Subject: 10CFR21 Reporting of Defects and Non-Compliance -
Engine Systems, Inc. Report No. 10CFR21-0105, Rev. 1

Subcover Assembly, P/N 1A-7846

10CFR21 REPORTING OF DEFECTS AND NON-COMPLIANCE

COMPONENT: Subcover Assembly, P/N 1A-7846

**Photo 1: Subcover Returned by Perry
(Incorrect)**

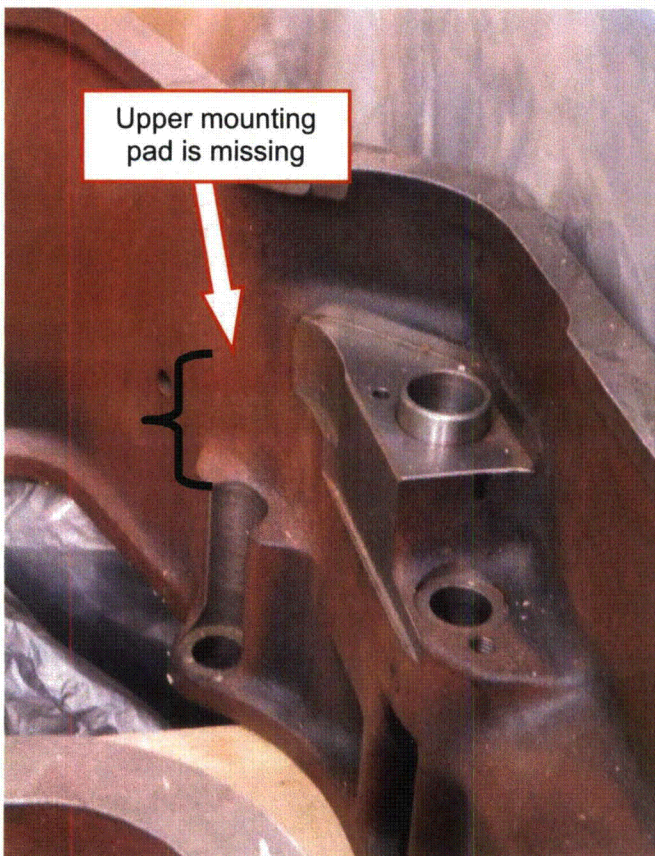
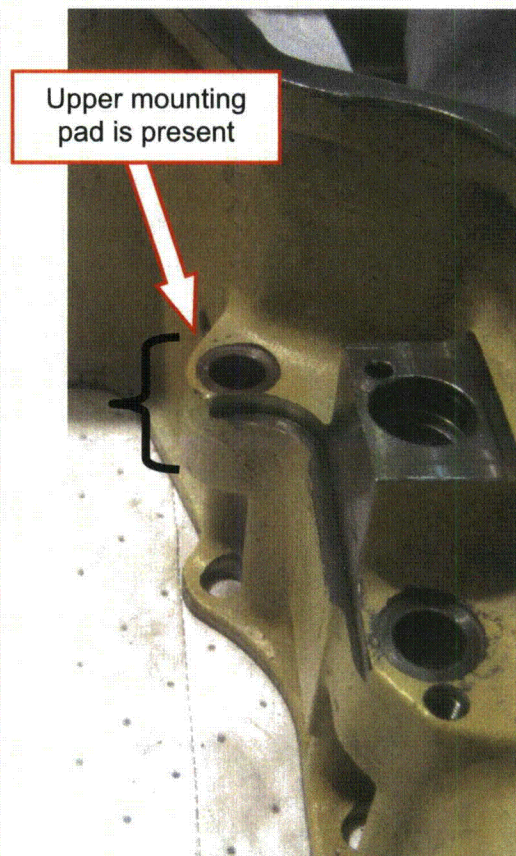
Engine Systems Inc. (ESI) began a 10CFR21 evaluation on 12/20/11 upon notification of an issue with four subcover assemblies at Perry Nuclear Plant. It was reported that Perry was performing a maintenance activity whereby they were replacing four cylinder head subcover assemblies on their Enterprise diesel engine. During installation, it was noted that qty 2 of the 11 bolt holes were missing an upper mounting pad. This was visually apparent once the customer attempted to install the bolts, which have a 6" length. The two areas missing the upper landing pad did not have an area for the underside of the bolt head to rest upon. See photos 1 and 2 below showing an incorrect vs. correct subcover.

Customers may elect to justify use of a shorter bolt to facilitate installation of in-stock covers. Otherwise it is ESI's recommendation that customers return the subcovers for replacement.

Figure 1: Overhead View of Subcover

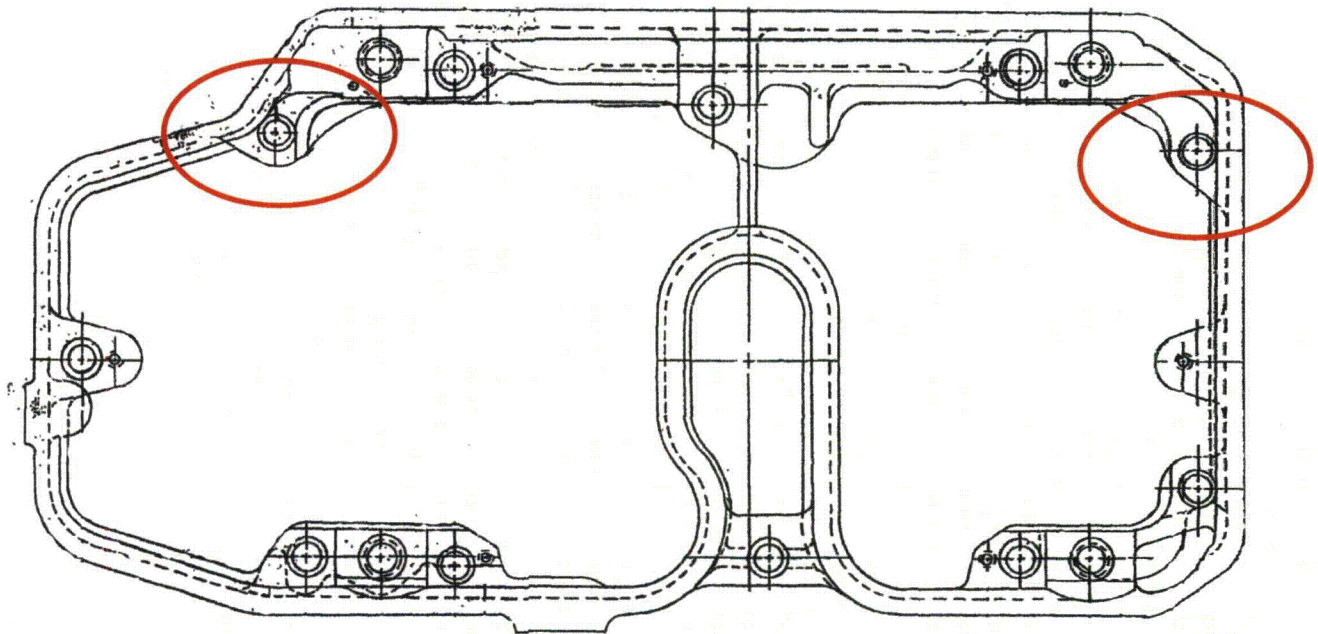
Figure 1 and photo 3 below show the positions within the subcover where the pads are missing.

Lack of the mounting pads alone will not result in a failure, however if a customer attempts to install the subcover without recognizing the missing material, there is the possibility that two of the eleven hold down bolts will provide no clamping function. This may result in loosening of the subcover mounting which could allow the cover to separate from the cylinder head.

The pattern is now being corrected to ensure the presence of the upper mounting pads. Also, ESI's dedication report is being revised to add specific checks to inspect for the presence of these pads. This will be completed prior to any future shipments of this item.
